**Subject: Exhibition of EIS - Yiribana Logistics Estate (SSD-10272349)**

## Attachment A – EES response to EIS for Yiribana Logistics Estate (SSD-10272349), 754-770 and 784-786 Mamre Road, Kemps Creek

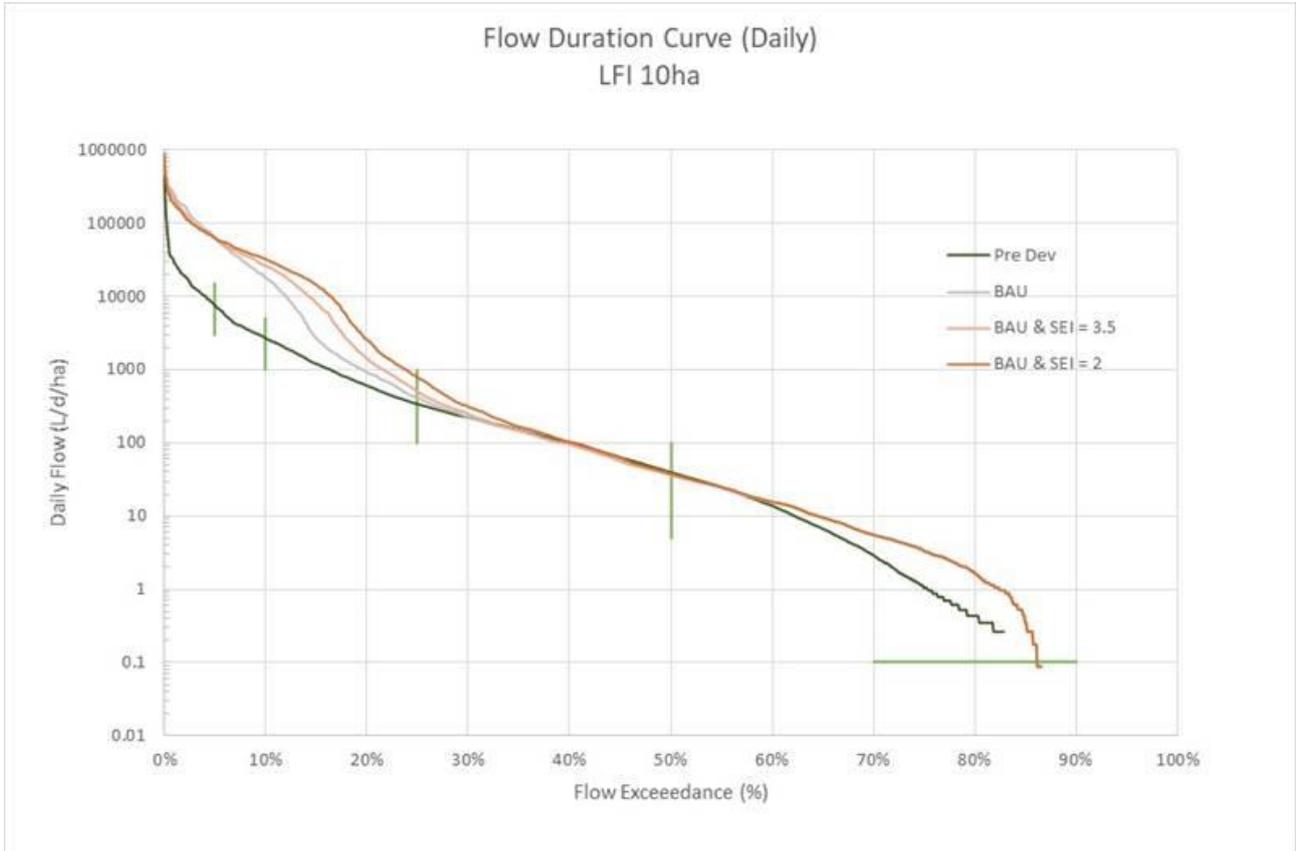
In regard to the applicant's approach, EES has undertaken a detailed technical study to assess whether the SEI is needed to achieve waterway health objectives. The study found the objectives will not be achieved without the appropriate flow duration percentiles as specified in the EES MUSIC toolkit (Table 3) which has been provided to the applicant. Please see below the flow duration curves for the following scenarios for example a 10 ha Large Format Industrial development:

- Business as Usual (BAU) treatment using just post development load reduction targets (85%, 65% and 45%).
- BAU + Storage to achieve SEI of 3.5
- BAU + Storage to achieve SEI of 2

The SEI focusses on large events (i.e. 98%ile and upwards) and ignores the remainder of the flow duration curve. As shown in the curve below, BAU approaches to complying with the SEI (storage to attenuate flows) simply transfer flow from one part of the curve and places this in another part of the curve (65% to 90%ile). In fact, it makes 80-90%ile part of the curve worse which based on waterway objectives will impact on instream habitat. Based on these results, applying the stormwater quality targets and an SEI of 2, in lieu of the proposed flow duration and MARV targets, will not ensure the waterway objectives are achieved.

Given the above, it unclear to EES if the waterway objectives and target are achieved under the applicants proposed design. EES therefore recommends that the applicant provide the following information from the EES MUSIC toolkit for further review:

- Post processor Spreadsheet showing that both quality and quantity targets and achieved, and
- MUSIC model files showing the parameters in the MUSIC toolkit.

Where the targets are not achieved, appropriate amendments should be made the design.
